15 April, 2020  
Ref.: 147/034-20 DC (Traff)

**RE: 84 Percival Road, Smithfield**  
**Alteration, additions for use of existing premises as a waste management facility**  
**DEVELOPMENT APPLICATION NO.: 2019 /0480**

I refer to Council's deferral comments letter dated 23 March 2020 of the above DA in regards to Items 1, 3 and 4.

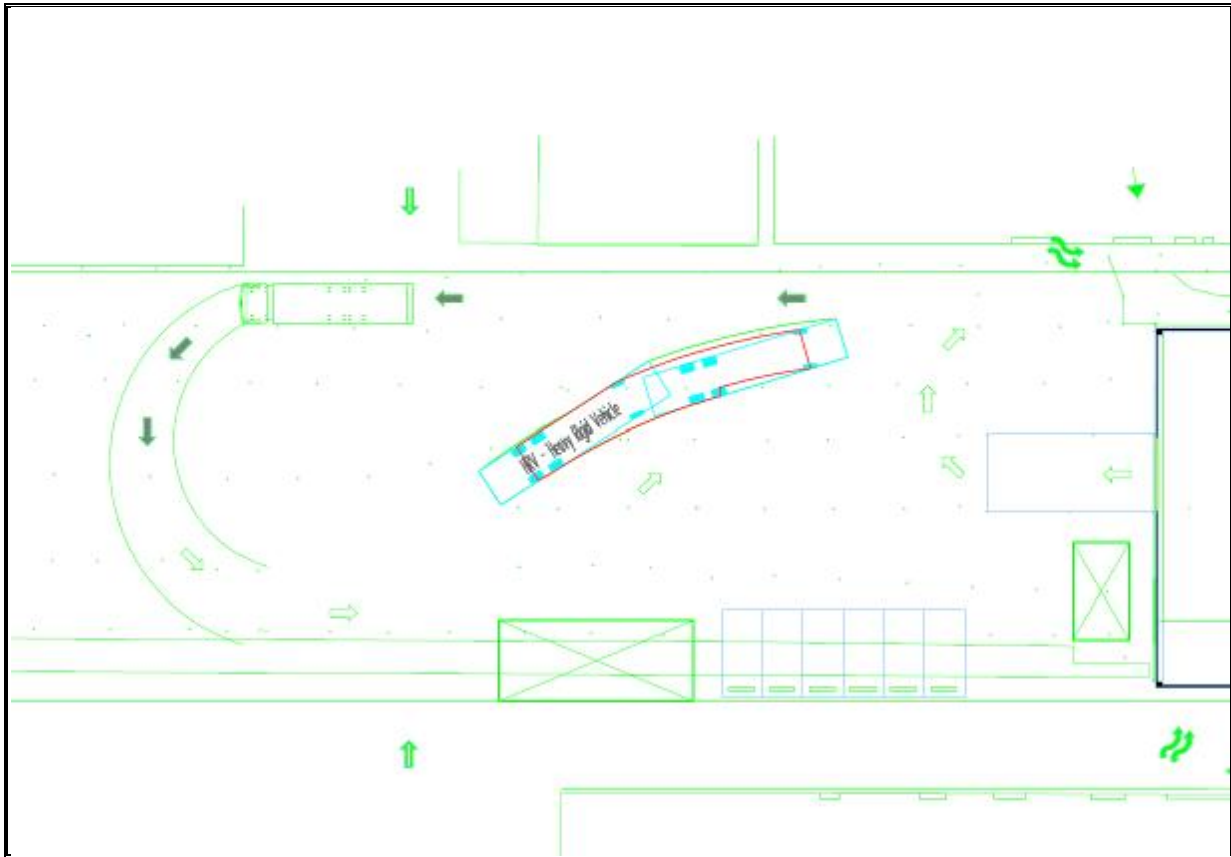
The applicant shall provide further information regarding the operations of heavy vehicles and the weighbridge. If the heavy vehicle will access the weighbridge at entry and exit then queue areas shall be provided within the site – It is noted that there may be traffic conflict during this process. In this regard, this matter shall be addressed.

In addition, the applicant shall also demonstrate that there is sufficient queuing area between the entry point and weighbridge for heavy vehicles that will enter the site based on traffic generation and delivery times.

We have demonstrated the worst case scenario of a HRV. The queuing at the entry point is as follows:

There is sufficient queuing areas both at entry and internal. There is one space at the entry to the weighbridge, however vehicles can also wait on the street for entry which would be rare.

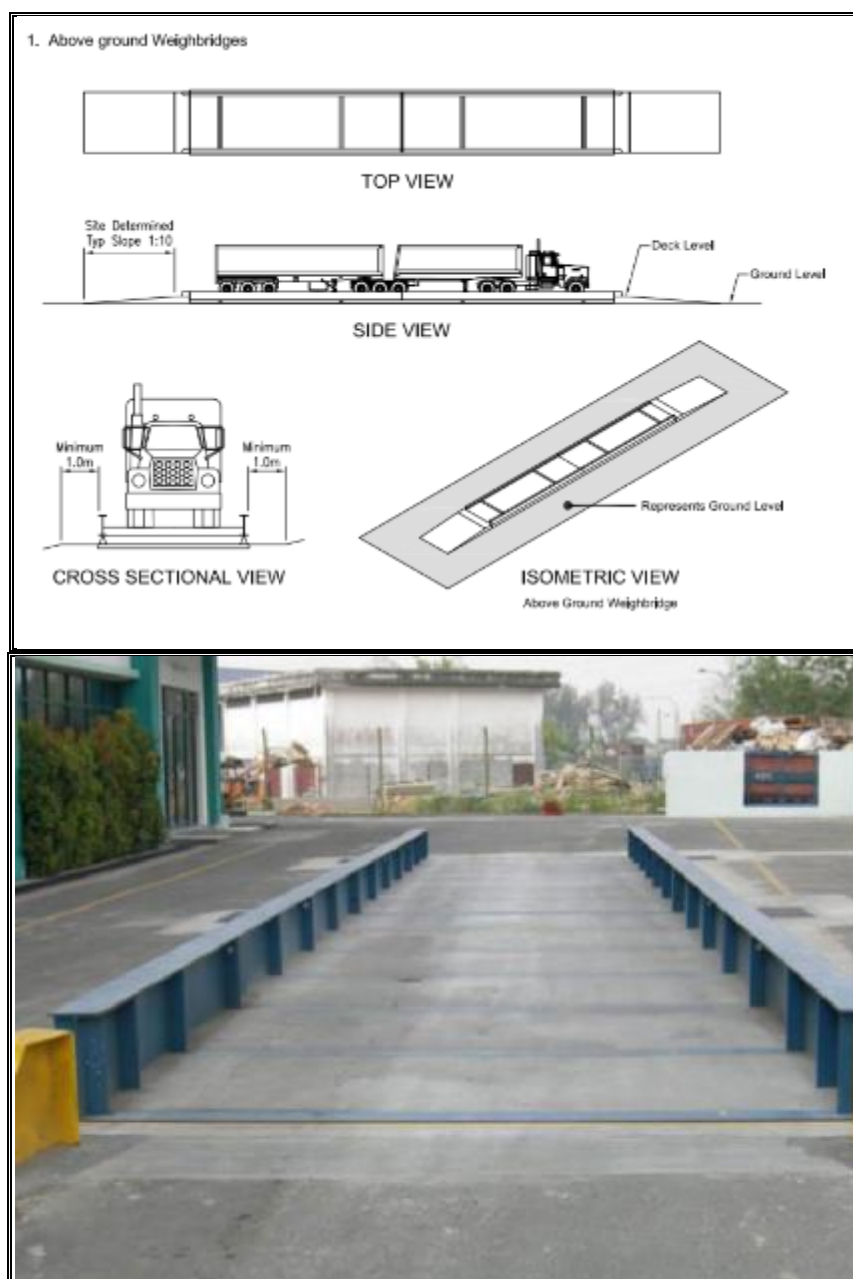
Plans show a nil setback proposed from the weighbridge to the northern boundary. Amended plans shall be submitted detailing any proposed works / treatment (i.e. retaining wall or fencing details) adjacent to the weighbridge to determine the impacts of its location upon the neighbouring property.

The Architectural drawings have been revised to eliminate nil set back.

Note that no retaining wall or changes to fencing is required.

The concept of the weighbridge is as follows:

## Attachment A: Car Park Layout

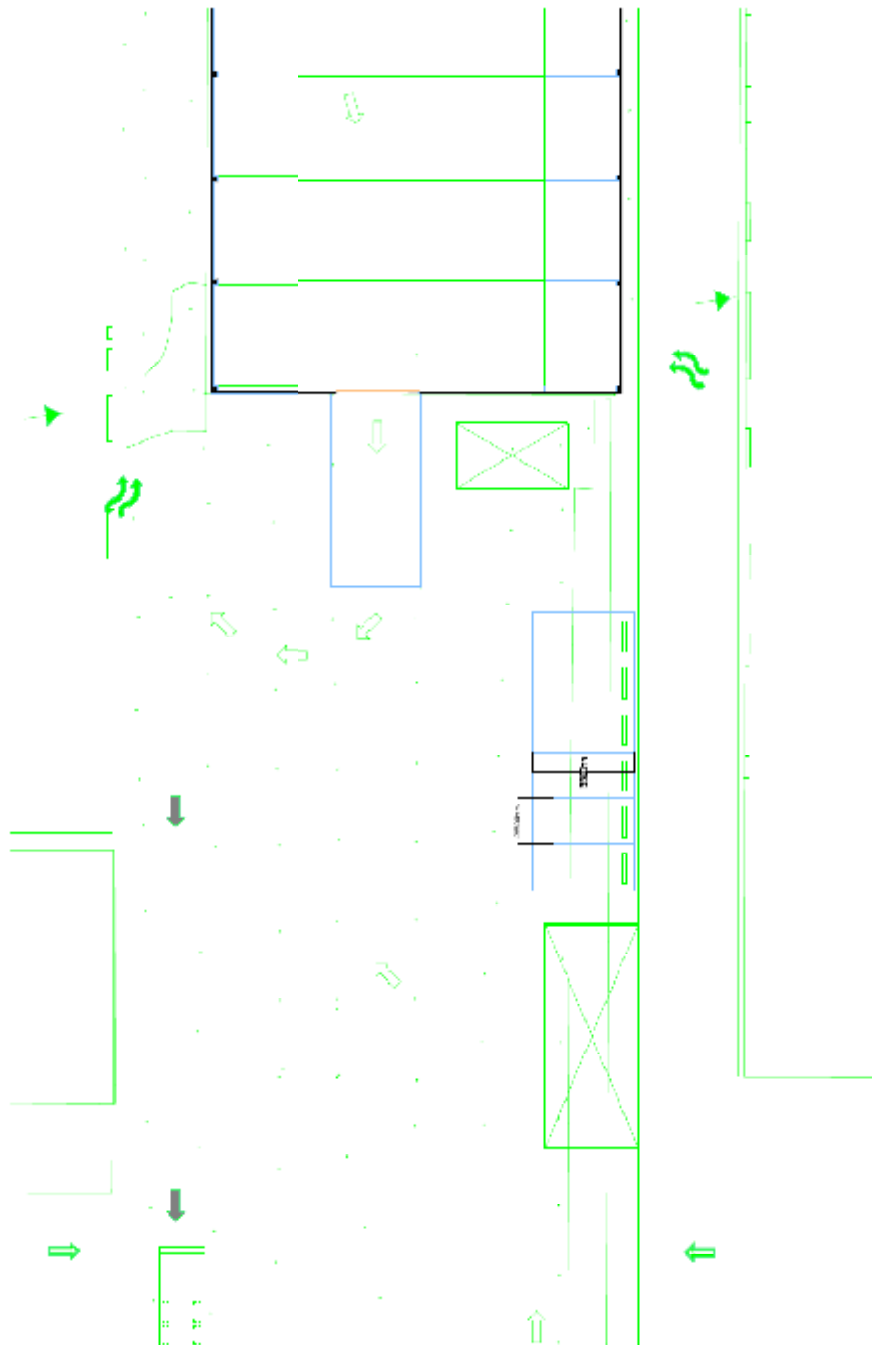
A minimum of 12 on-site parking spaces is required to be provided based on the warehouse and office gross floor area of the building. The provision of 9 parking spaces is a short fall of 3 parking spaces.

The submitted SEE and Traffic and Parking Assessment outlines that there is a total of 8-9 employees at any one time during the daily operations of the business. It is also noted that the premises would also accept private vehicle loads, in which may require parking on-site upon visit. It is requested that further information be provided with regard to the management of private vehicles visiting the premises, to support the provision of 9 parking spaces on site for the proposed use. Alternatively, 3 additional parking spaces shall be provided on-site to accommodate a total of 12 parking spaces (inclusive of 1 accessible parking space).

The revised proposal provides 12 parking spaces as follows:

- Area A – 6 spaces including a Disabled parking space
- Area B – 6 spaces

Please refer to Attachment A for detail.

## Attachment B: Swept Paths

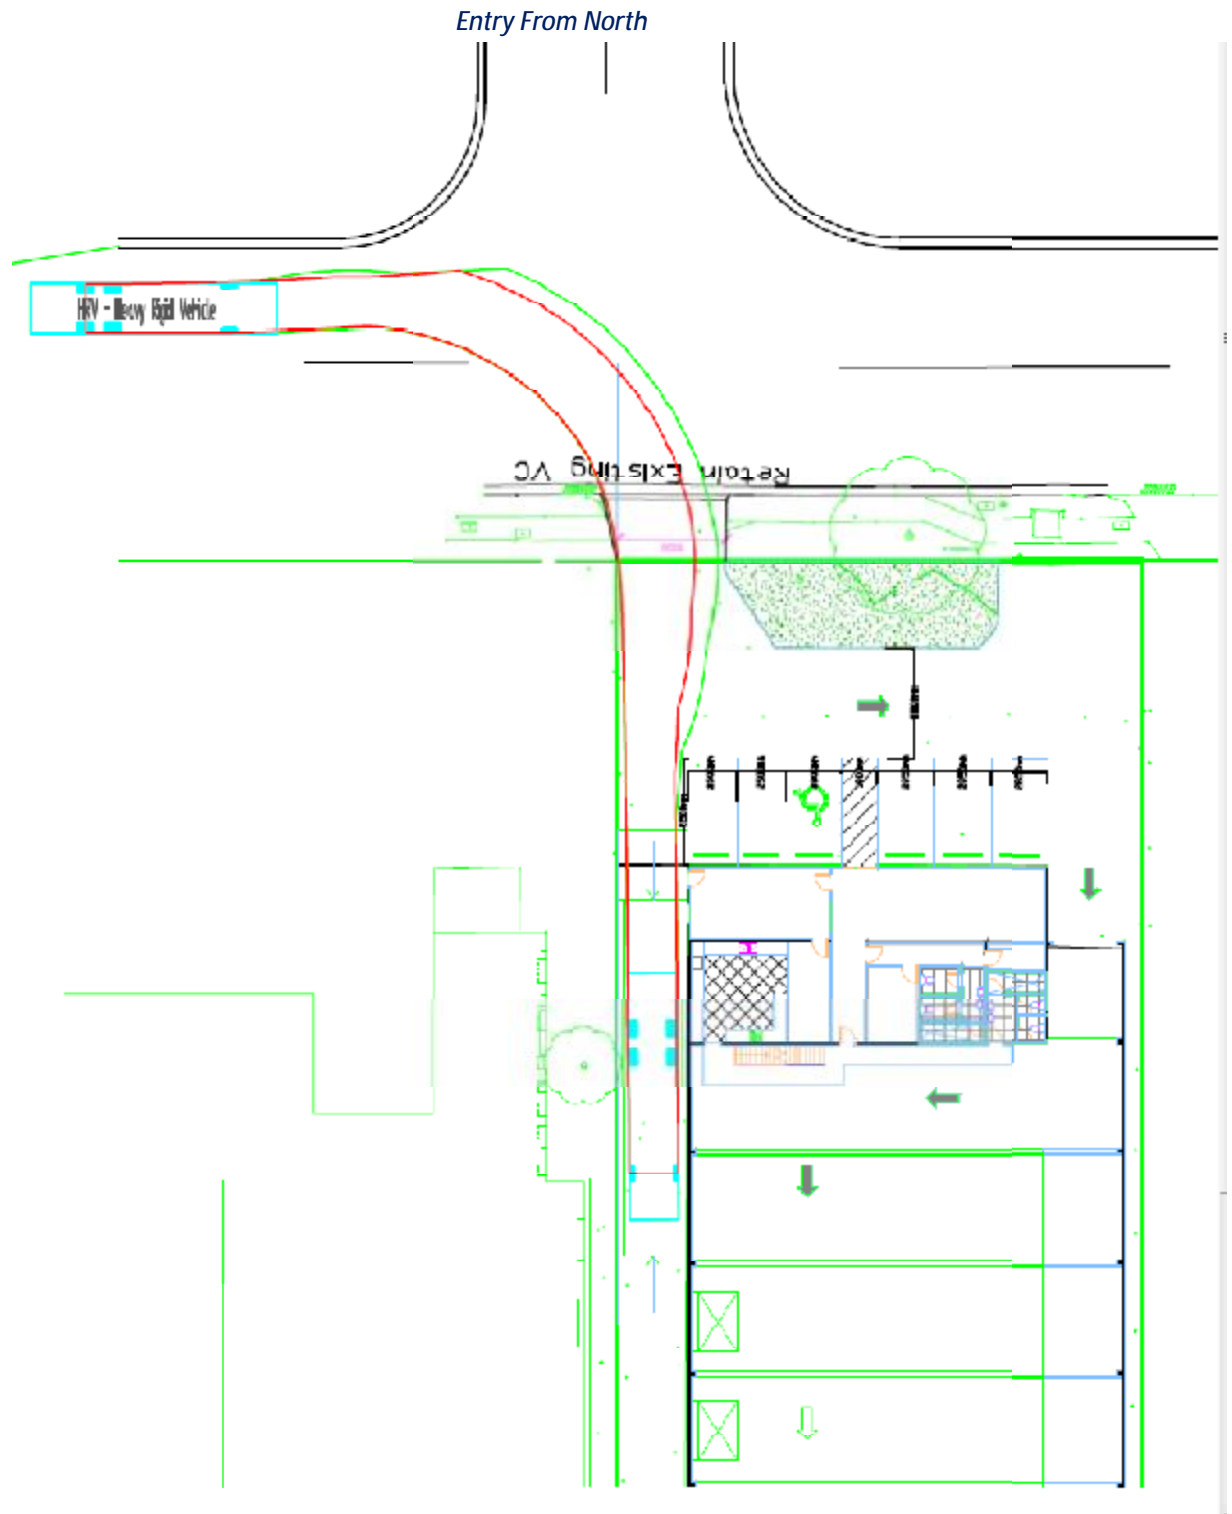
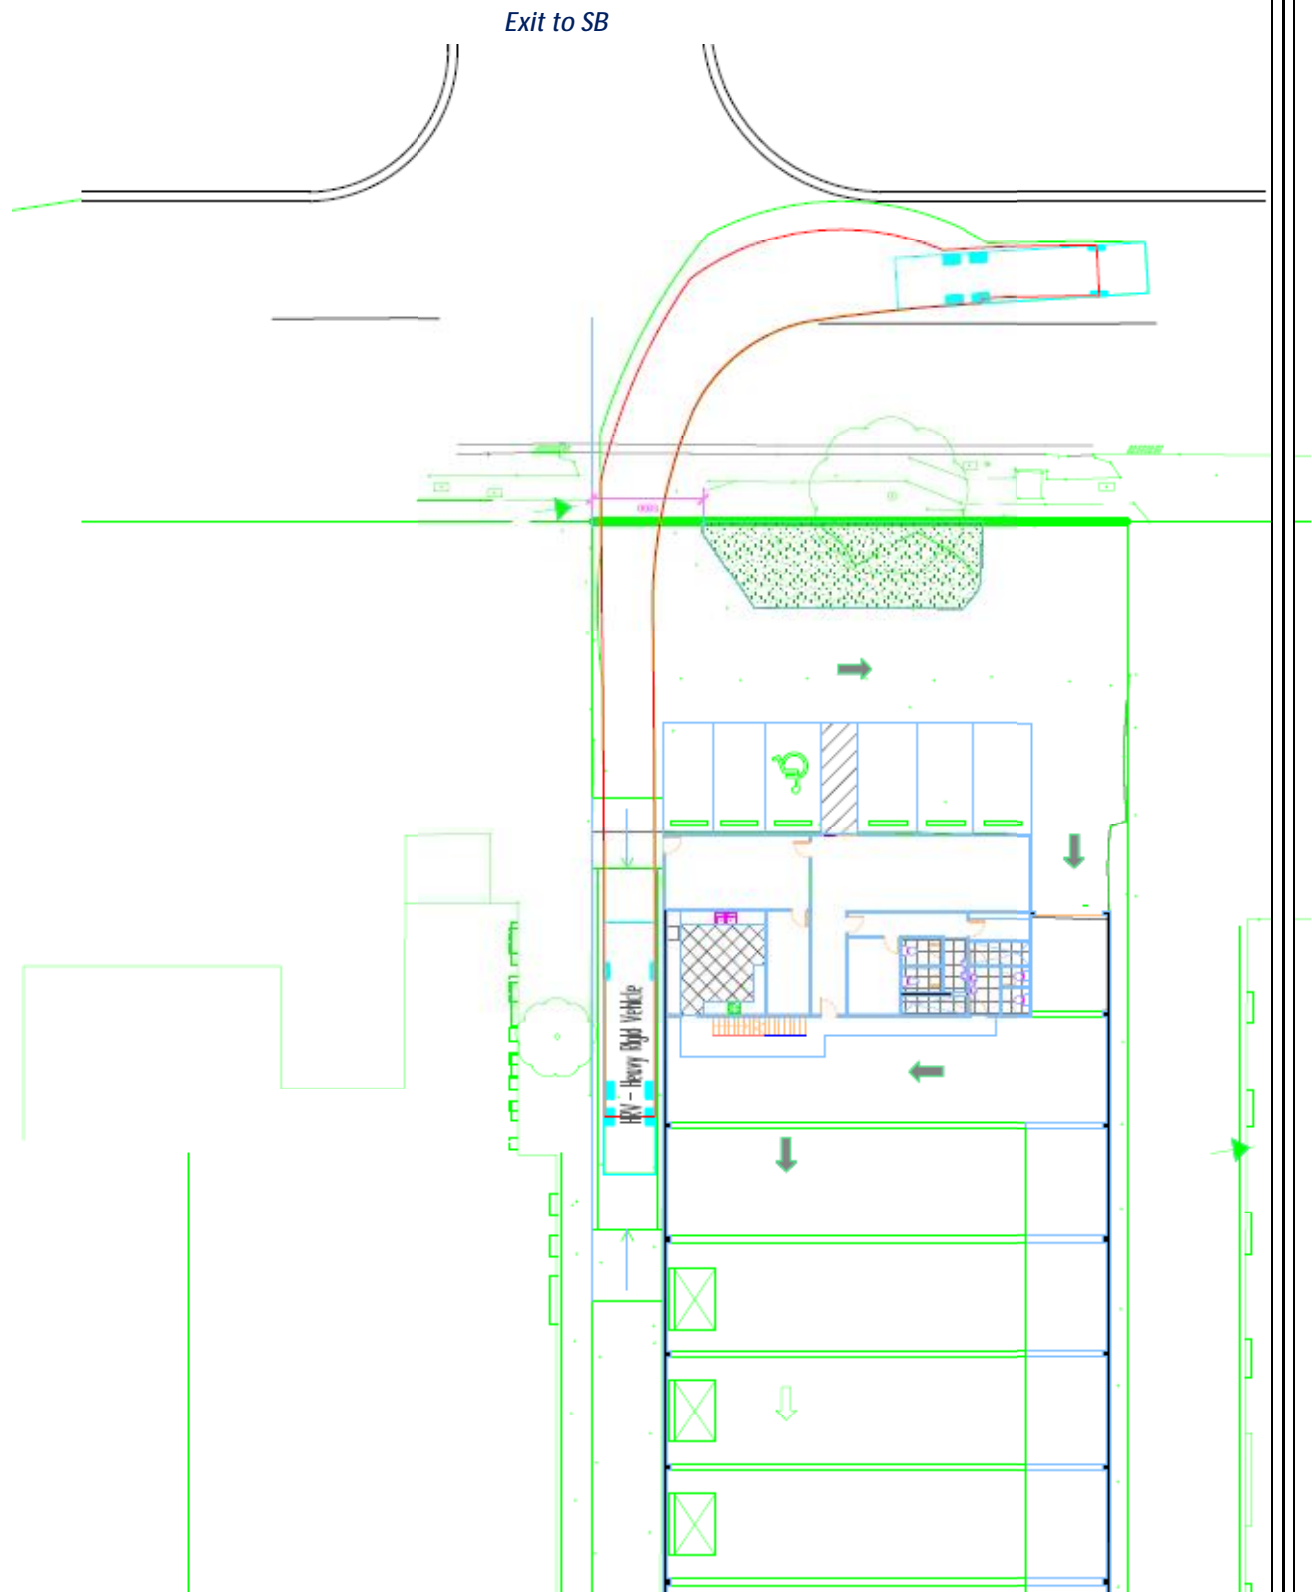
- c) The location of loading and unloading area for the largest vehicle that will entre/exit the site in a forward direction.

- d) Swept path analysis shall be provided demonstrating the following:
- The largest heavy vehicle (e.g., heavy ridge vehicle as mentioned in the report) can enter, manoeuvre within the site and exit in a forward direction.
  - A vehicle can pass another B99 vehicle and a largest heavy vehicle at intersection points and at curved section of the driveway.
  - The largest vehicle entering / exiting the site is not encroaching onto road centre line and / or parked vehicles on the frontage roads etc.

Please refer to Attachment B. Swept paths demonstrate manoeuvrability of largest vehicle (HRV) loading / unloading and entering /exiting the site in a forward direction.

Part i) demonstrating the largest heavy vehicle (HRV) entering and manoeuvring within the site and exiting in a forward direction is shown in Attachment B.

Part iii) demonstrating the largest heavy vehicle (HRV) entering/exiting the site without encroaching onto the centre line is when HRV enter from north and exit to the south. This will be the agreed travel to this site with the clients. However, if this is breached, HRV can still travel as shown in Attachment B on the other side of the road in accordance with Australian Road Rules and safely enter the weighbridge station.
